Groundwater Application Review Summary Form

Application # G- 19328

GW Reviewer Gabriela Ferreira Date Review Completed: December 4, 2023

TO: Water Rights Section Date December 4, 2023
 FROM: Groundwater Section Gabriela Ferreira
 Reviewer's Name
 SUBJECT: Application G- 19328 Supersedes review of _____
 Date of Review(s) _____

Well Statistics

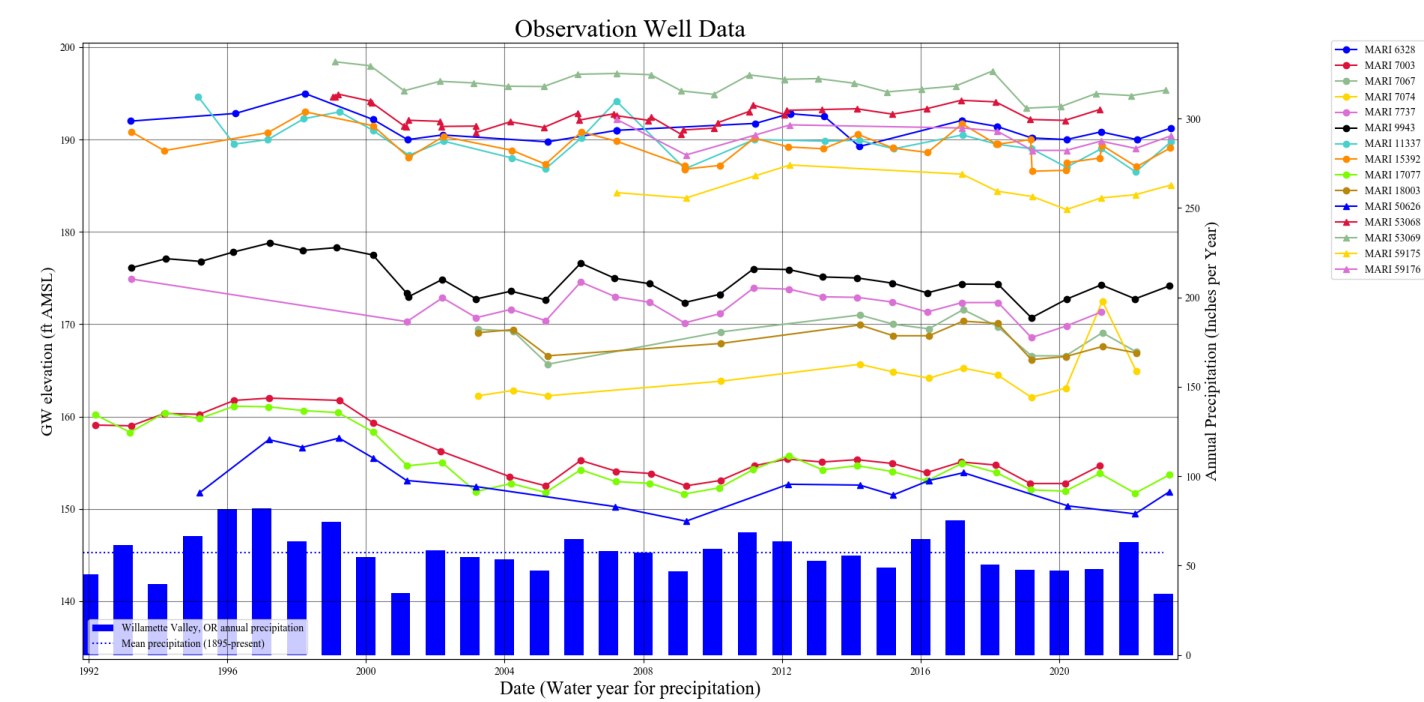
Median yield for nearby wells was 50 gallons per minute and typically ranged from 10 to 200 gpm with a few wells producing 200 to 1200 gpm (see attached well statistics). The reported yield for the proposed POA, MARI 7668, was 1000+ gpm by air test in 1978. The requested rate of ~834 gpm is within the upper range of nearby wells.
